I've reviewed the stage/depth output you sent to me for the LECSTM calibration/validation. I strongly suggest that someone like Gwen Burzycki (MD- DERM), who is intimately familiar with on-the-ground conditions/trends in the study area, also be consulted for this type of soft-calibration effort.

The following are my observations of the data you provided in your April 5, 2006 e-mail.

PM103

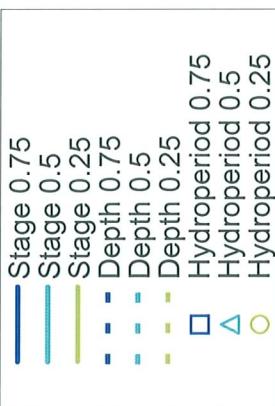
100, 101, 102, 103 – calibration/validation stages at/near the model's land surface elevation seem reasonable. Shorter than desired hydroperiods resulting from the calibration/validation seem consistent with existing landscape concerns.
Calibration/validation stages at higher and lower end of the spectrum may be exhibiting a slight positive bias. However the calibration/validation stage hydrograph patterns are more similar than not to patterns of discharge observed in the DBHYDRO S18C data (via visual inspection).

PM4

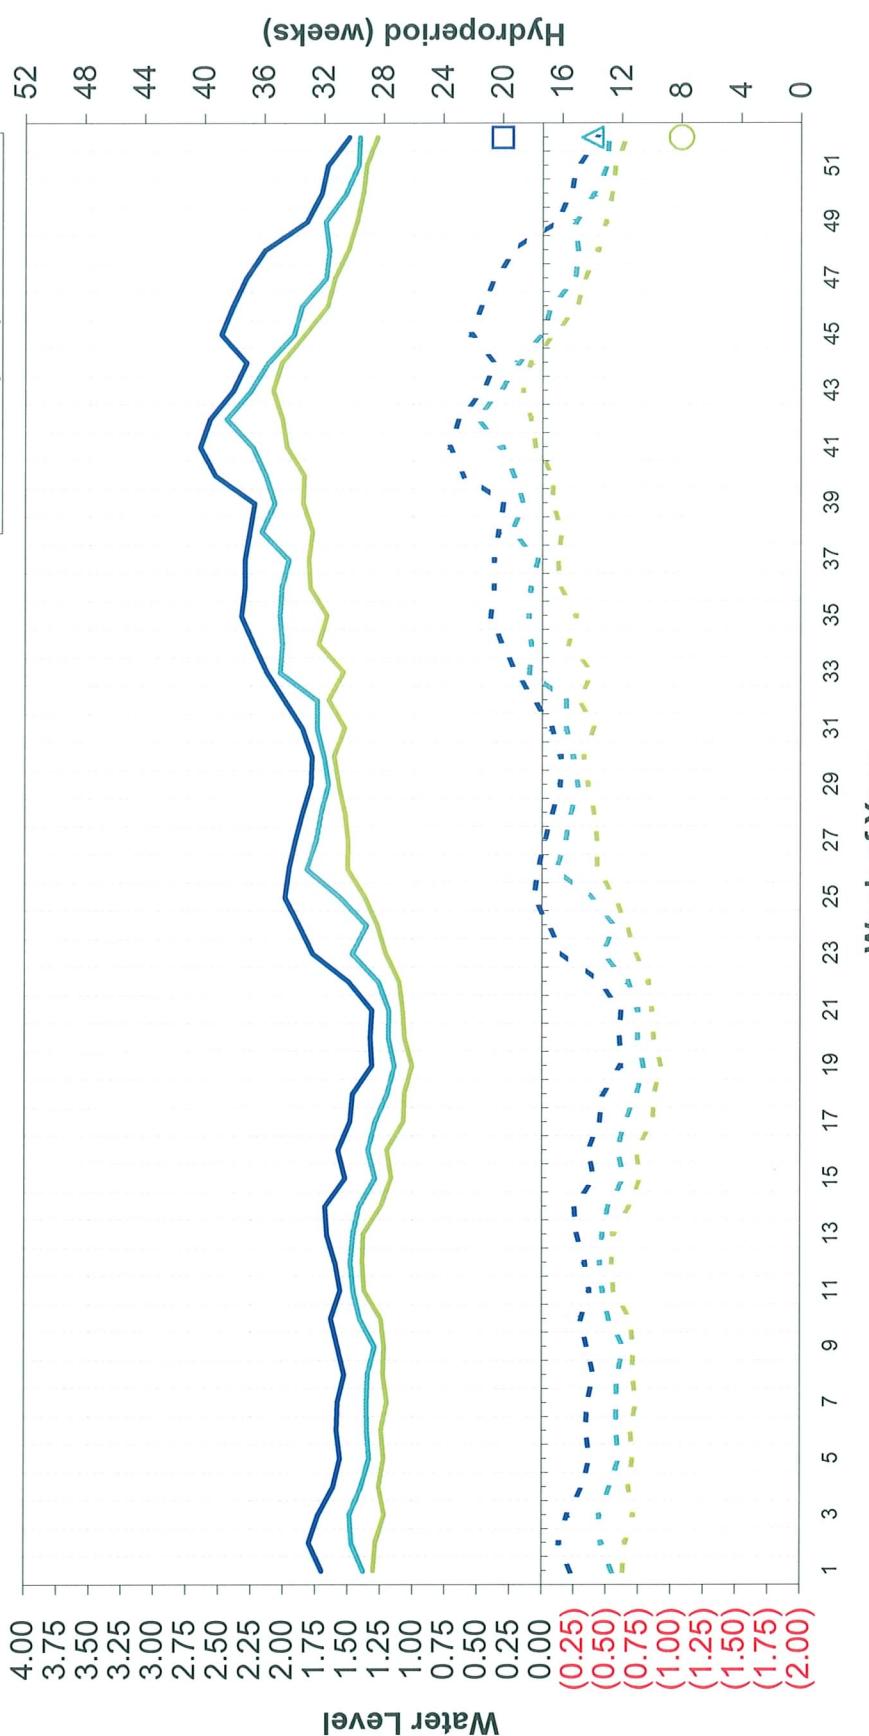
4 – calibration/validation stages at/near the model's land surface elevation seem slightly low (maybe 0.25' to 0.5'). Hydroperiods resulting from the calibration/validation at this location seem too short (maybe 8-14 weeks).
